ZONING BOARD OF APPEALS  
REDDING, CONNECTICUT

APPLICATION FOR:

Re: Certificate of Zoning Compliance at 29 Goodsell Hill Road.

ZONING LOCATION SURVEY MAP  
 PREPARED FOR  
**RYAN A. FLETCHER**  
 29 GOODSSELL HILL ROAD  
 REDDING CONNECTICUT  
 SCALE—1"=30' APRIL 21, 2016  
 AREA = 2.1141 ACRES

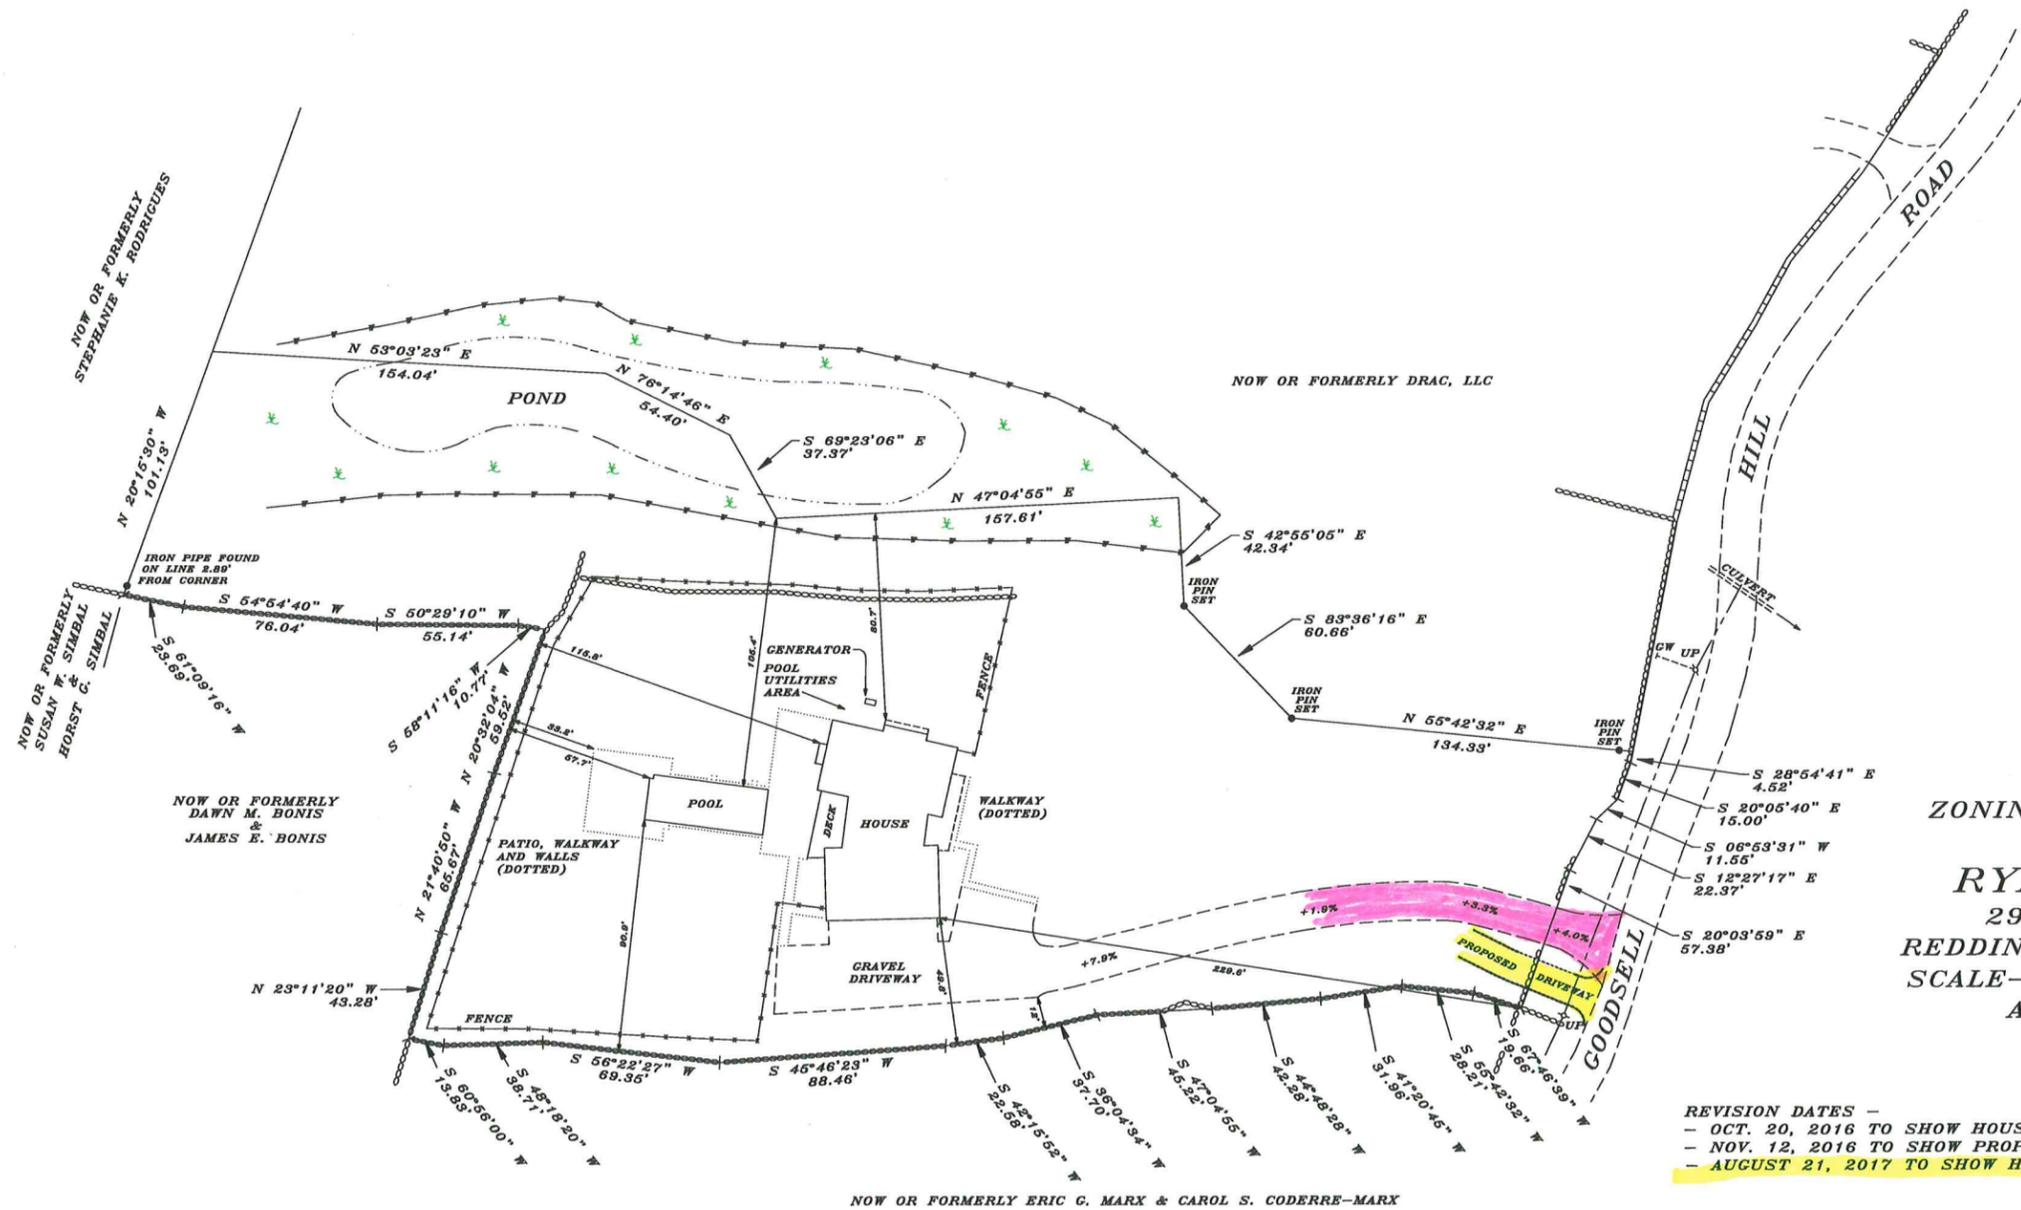
This office is in receipt of an as-built survey of your property at 29 Goodsell Hill Road; an inspection of the property was conducted yesterday. A review of the survey and the subsequent inspection found that the following issues must be resolved prior to the issuance of a Certificate of Zoning Compliance for the dwelling at 29 Goodsell Hill Road:

- *Corrected Aug 2019* Parking spaces have been created to the south of the dwelling. Per my correspondence to you of May 9, 2016 (and in accordance with Section 5.6.4 of the Redding Zoning Regulations), parking spaces must be 25' from side property lines. The size of the existing parking area therefore needs to be reduced.
- *Corrected Fall 2017* Per Section 3.8 of the Redding Zoning Regulations, all driveways must be paved for the first 20 feet back from the travelway of the frontage road. The driveway is currently all gravel.
- *Variance Request* Per Section 3.8 of the Redding Zoning Regulations, the minimum sight-line distance, measured at 15 feet back from the travelway of the frontage road, must be 250' to approaching vehicles in both directions. The driveway does not appear to meet that standard in either direction.

Once these issues have been resolved, please submit a revised survey to this office indicating that the property has been brought into compliance with the regulations. Thank you for your attention to this matter.
